**Re: 250 Turnpike Road / 0 Parkerville Road, Southborough, MA
Civil Engineering Peer Review – 1**

Howard Stein Hudson (HSH) is pleased to provide the Southborough Zoning Board of Appeals and Conservation Department with this review of the Site Plan, Stormwater Management Report, Subsurface Disposal System Design, and the Traffic Impact Study prepared and submitted under MGL Chapter 40B. We have received the following documents as part of this review:

Below and attached is the peer review for the 250 Turnpike Rd. Southborough, MA Landscape Plan:

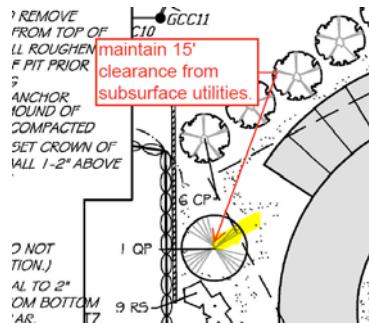
1. Plant list – indicate locations of non-combustible (non-mulch) areas on plan. Provide alternative ground cover.
2. Tree Planting Detail – include note to “expose root flare” for new tree plantings.

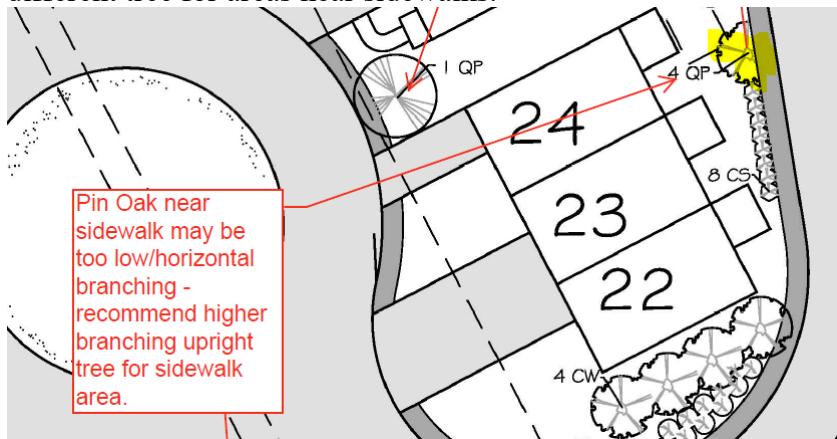
3. Section 174-13-B.5 indicates that tree staking be removed after 1 year. Adjust tree planting detail to comply.
4. Subsurface utilities are indicated on the plan. Large Pin Oak trees are proposed near this utility. Ensure a minimum of 15' clearance from the tree to the utility.

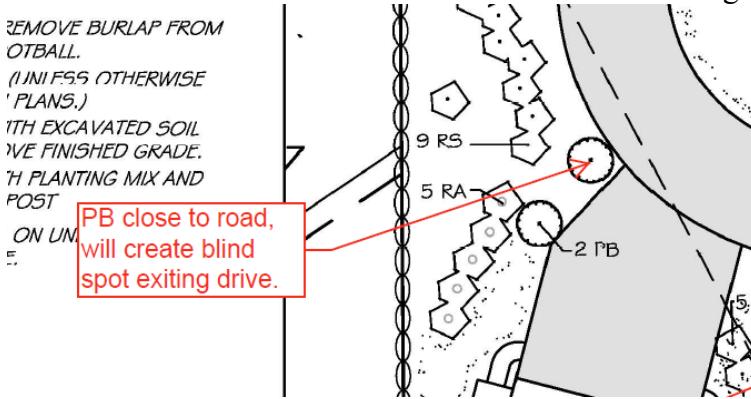
5. Pin Oak trees are low / horizontal branching with a wide canopy. Recommend a different tree for areas near sidewalks.

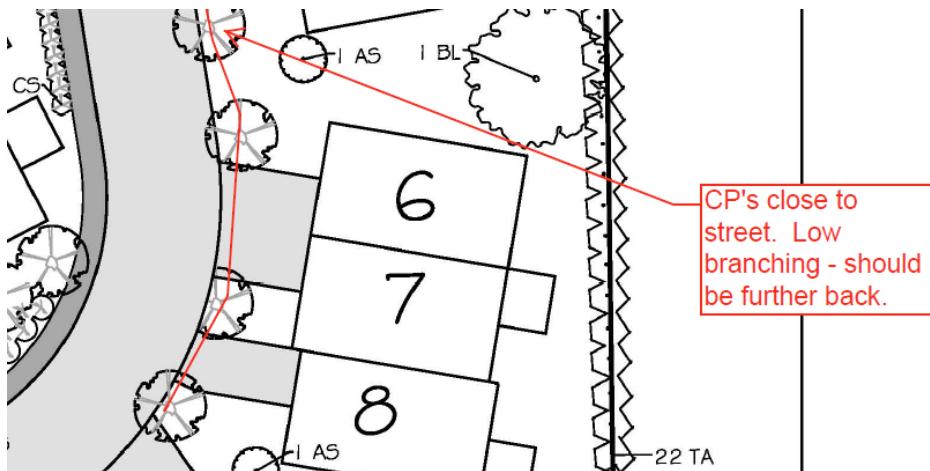
6. "PB" indicated close to street. Should be set back for sight lines and future growth.

7. Indicate type of grass to be used to ensure it is drought tolerant as per waiver request.

8. North Arrow should be included on plan. Evergreens at bottom of sheet (South?) appear to be mis-labeled.

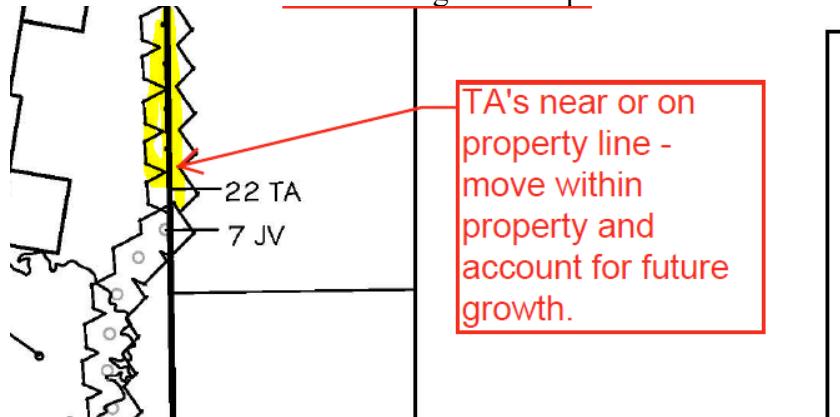
9. CP plantings are shown too close to the street considering the tree size/shape:

10. Several plants are not drought resistant as indicated in the waiver request. See plan for types in question.

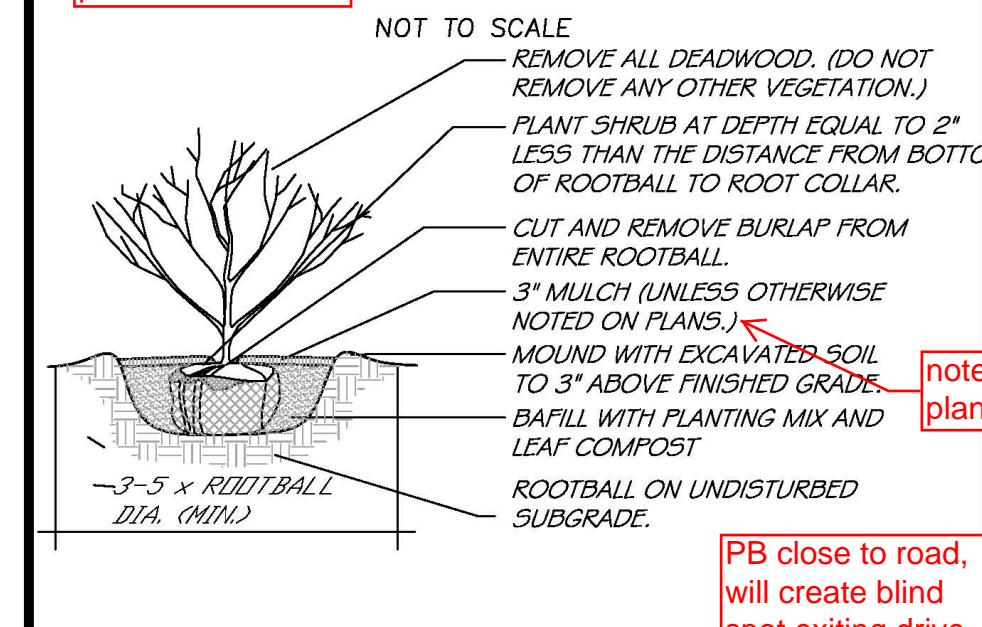
remove after 1 growing season per 174-13.B.5
